The Boston Garden

BOSTON PROPERTIES AND DELAWARE NORTH COMPANIES

DESIGN DEVELOPMENT SUBMISSION TO **BOSTON REDEVELOPMENT AUTHORITY**

FEEDBACK FROM PREVIOUS BCDC PRESENTATION

SPLIT STAIR

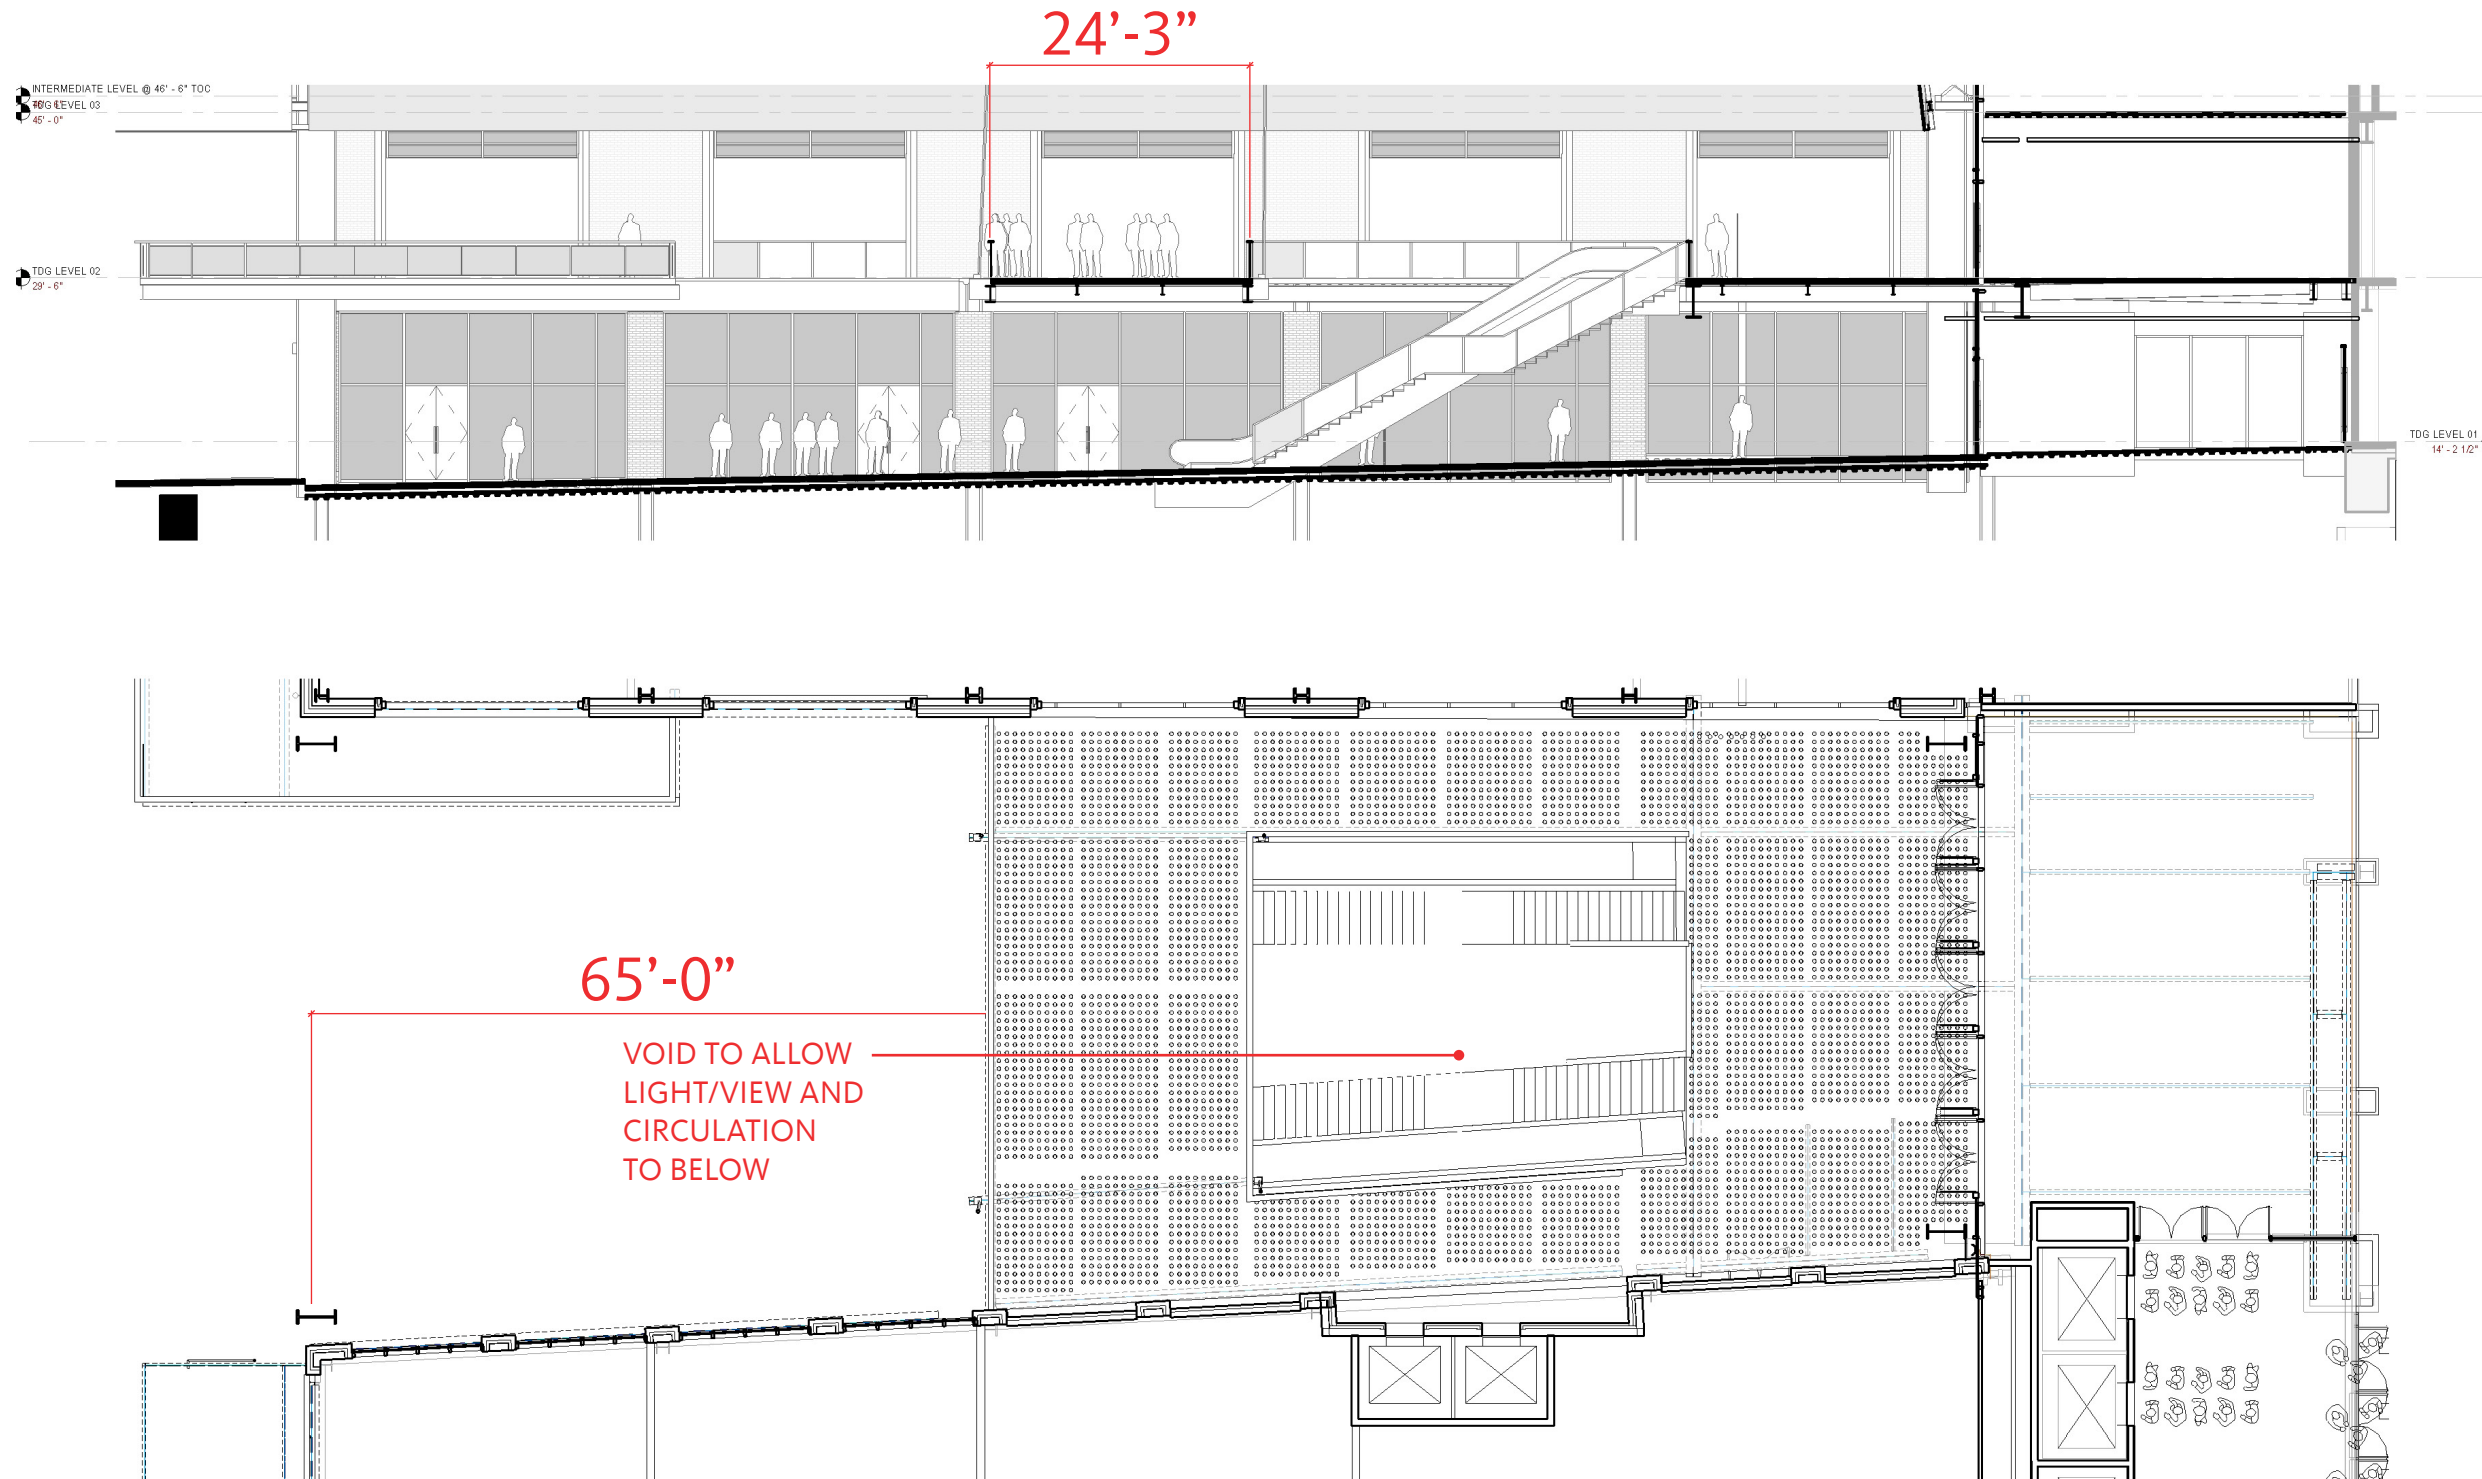
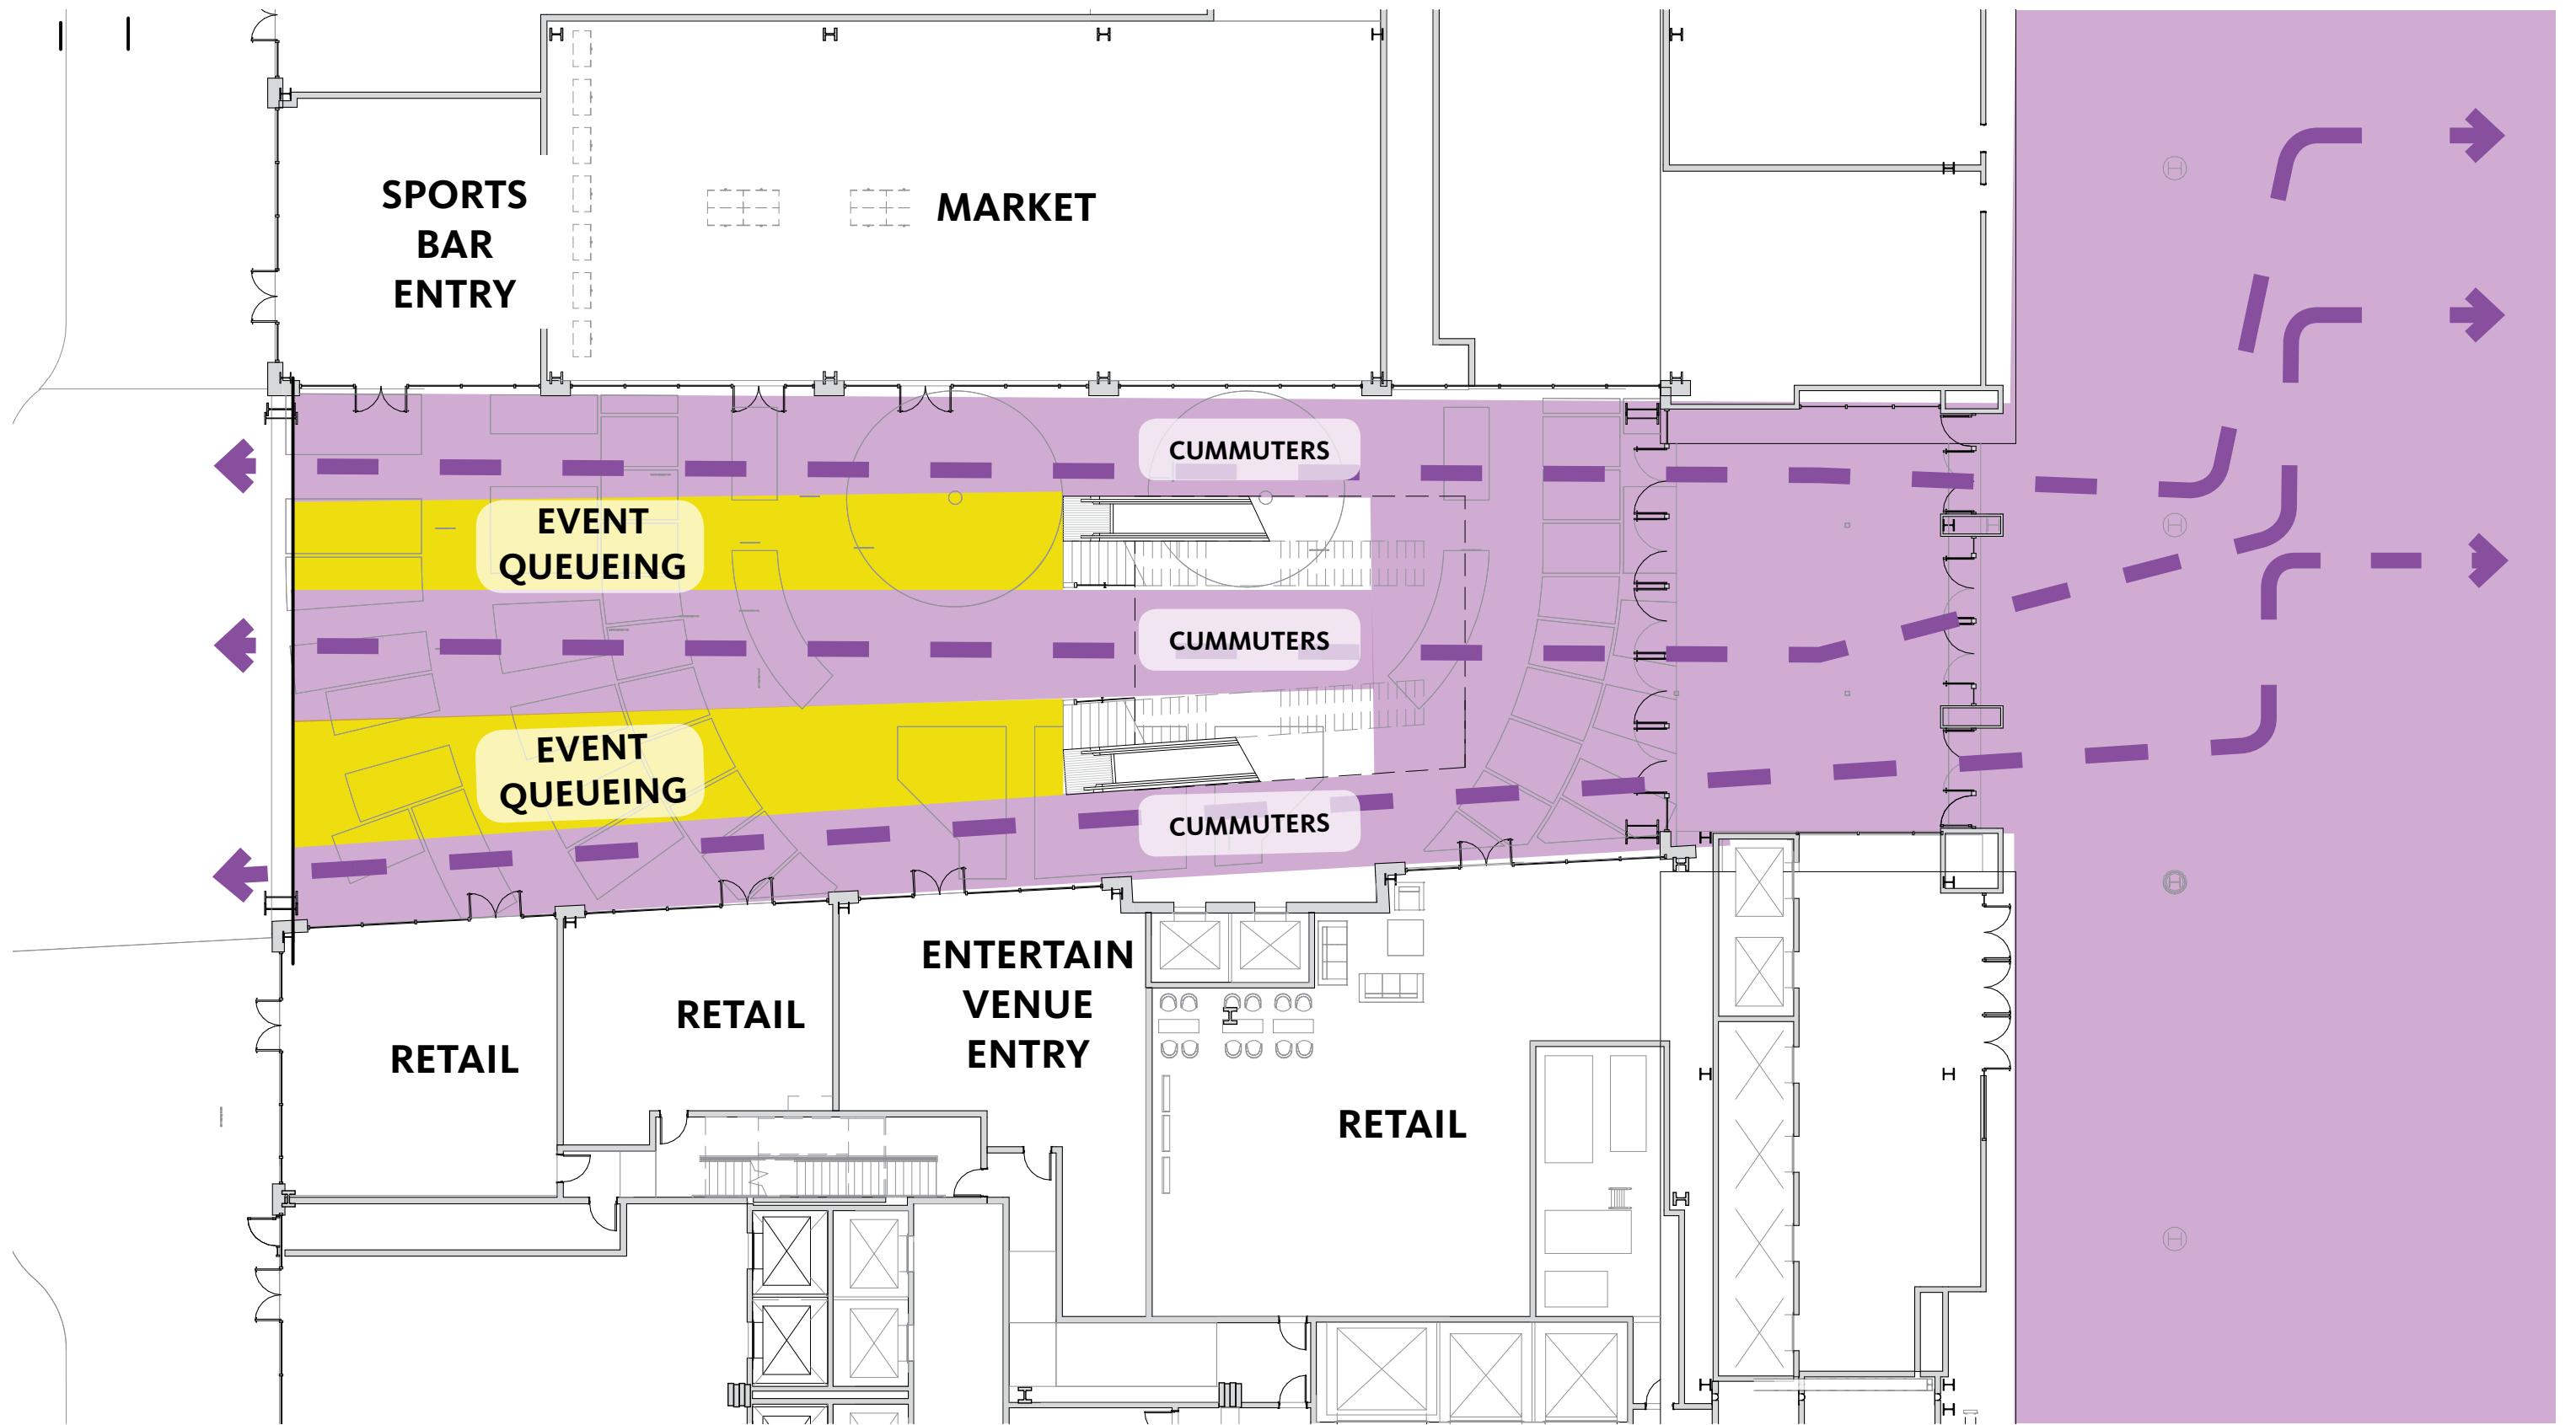
SATISFIES DRIVERS?

1. PEDESTRIAN FLOW
NO, FLOW IS PINCHED ON BOTH SIDES, AND QUEUEING AND CIRCULATION ARE CONFUSED AND DIFFICULT TO CONTROL IN THE CENTER.

2. A PLACE ABOVE
YES

3. VISIBILITY AND ACCESS TO RETAIL TENANTS
NO, BOTH SIDES OF THE SPACE ARE CONGESTED WITH CIRCULATION FLOW, AND THE ESCALATORS SO CLOSE TO THE SIDES BLOCK VISIBILITY.
